# Product Change Notification

**Product Change Notification:** E-20-014948

PRODUCT GROUP DRAWING FOR JUNIOR POWER TIMER CONTACT

**Customer Drawing(s) Being Modified:**

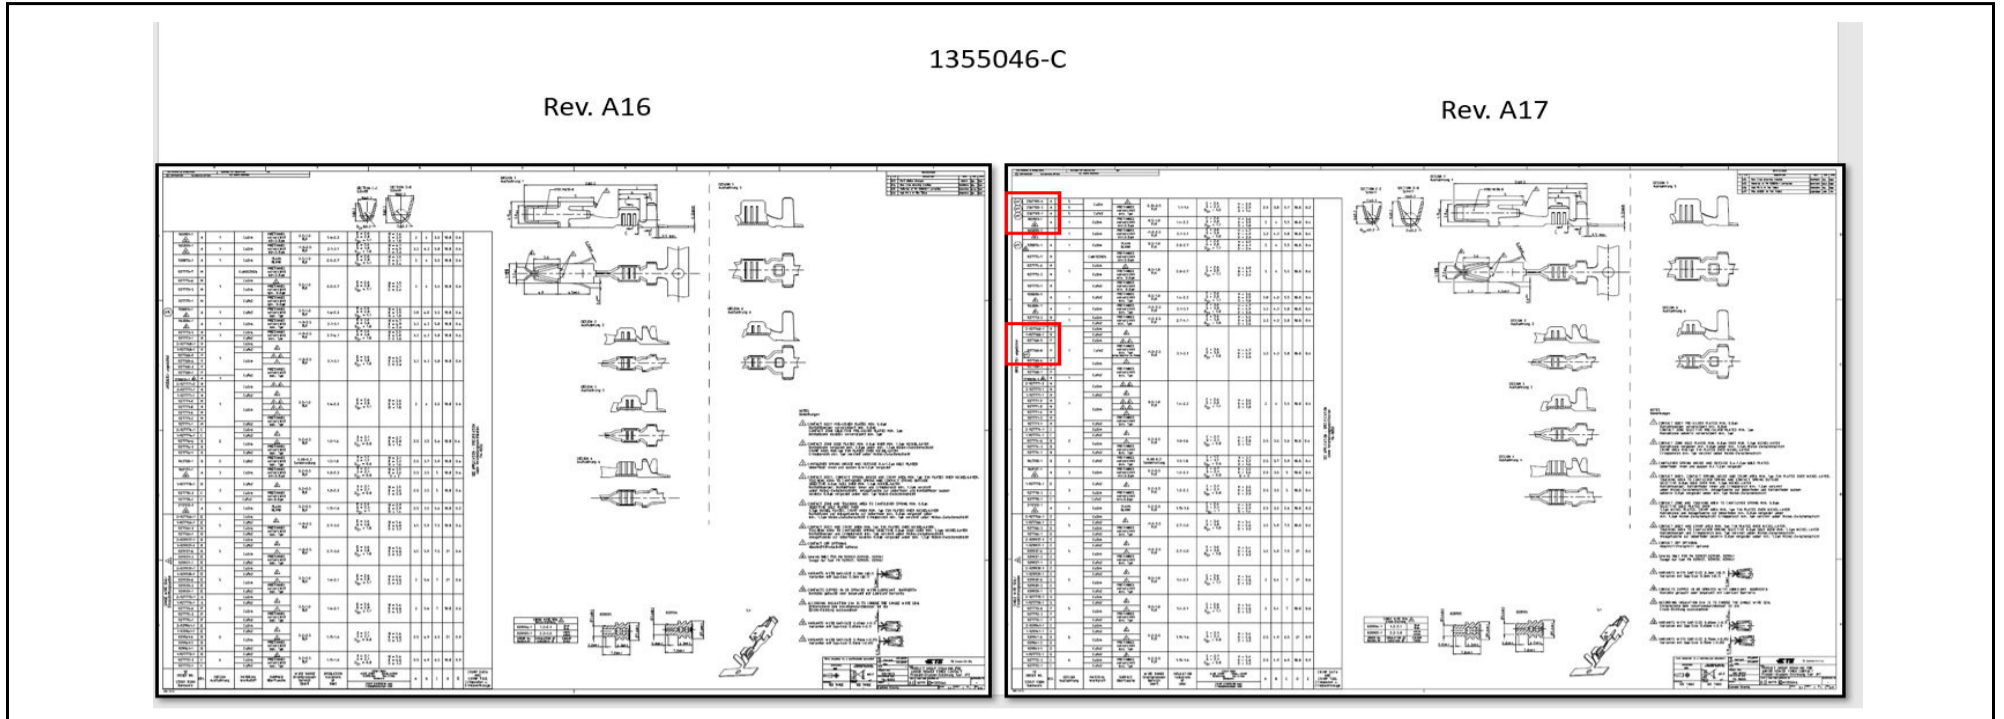
Drawings are Updated for the following affected items (PNs 2367105-6, 2367105-3, 2367105-1 and 927768-8 are added in the Table)
